G-002-001

**SUBJECT: URBAN DESIGN ADVISORY GROUP COMMENTS TO THE DRAFT
 ENVIRONMENTAL IMPACT STATEMENT**

DRAFT - Design Guidance for the Columbia River Crossing Project

Exhibit 3-5. Hayden Island LRT Station and I-5 Crossing

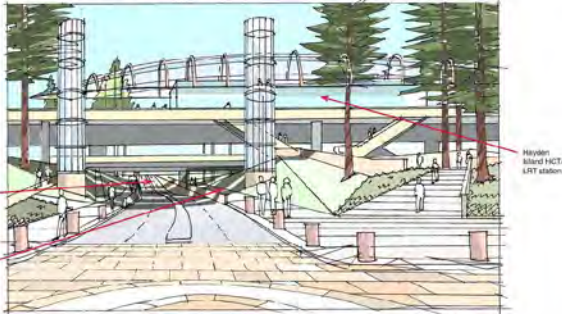
11. Locate the station directly above Tomahawk Drive, aligning access and landscape with the planned east-west corridor. Align transit station with Tomahawk Drive.

15. Increase separation between ramps at the Hayden Island interchange to enable creation of generously planted landscaped terraces. Use this landscape also for natural treatment of storm-water runoff. Design noise walls and berms integral with the interchange to reduce noise trespass to the east and west. Space ramps to admit daylight and generous landscaping.

Exhibit 3-6. Columbia River Spans

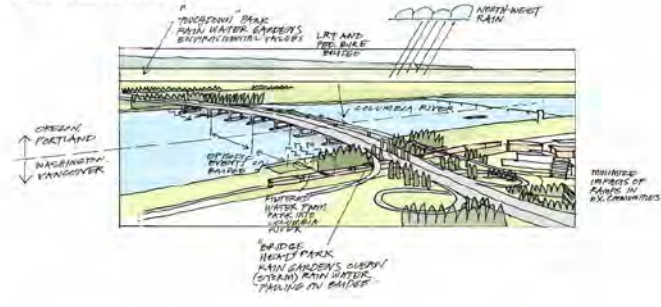
16. Members of the LDAG recommend that the FAA be approached to consider a greater height allowance for the north end of the CRC span, permitting consideration of bridge types other than girder and box girders. (It has been suggested that an element of interpretation by FAA staff has been involved in setting the imaginary surface height restrictions, and that a different interpretation might change the limits on bridge type).
Challenge: maintain bridge form.

17. Use constraints on height and clearance over the water to inspire a great and unique design solution. (Explore the feasibility of a composite box girder bridge with open webs). *Find alignment and dimensional constraints.*

18. Minimize the number of piers in the river, consistent with reasonable economy. *Locate fewer piers in the river.*

3.2.9 Mill Plain Interchange

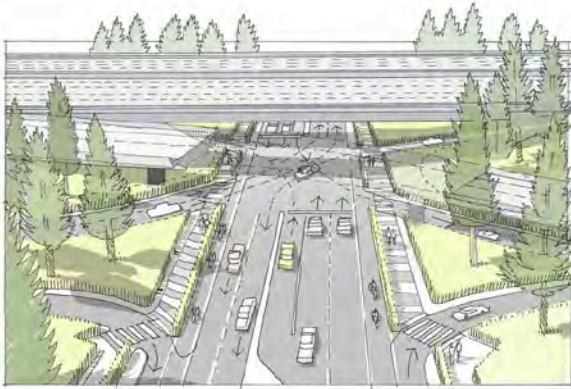
38. Acknowledge through urban design and landscape that Mill Plain is the principal point of access to Downtown from the north and east. *Recognize the Mill Plain interchange as the principal entrance to Downtown.*

39. Provide safe and direct passage for pedestrians and cyclists on Mill Plain Blvd traveling between destinations east and west of I-5. (The current design appears to address only vehicular traffic needs. Prepare another design that accommodates all modes equitably). *Improve pedestrian and bicycle safety under I-5.*
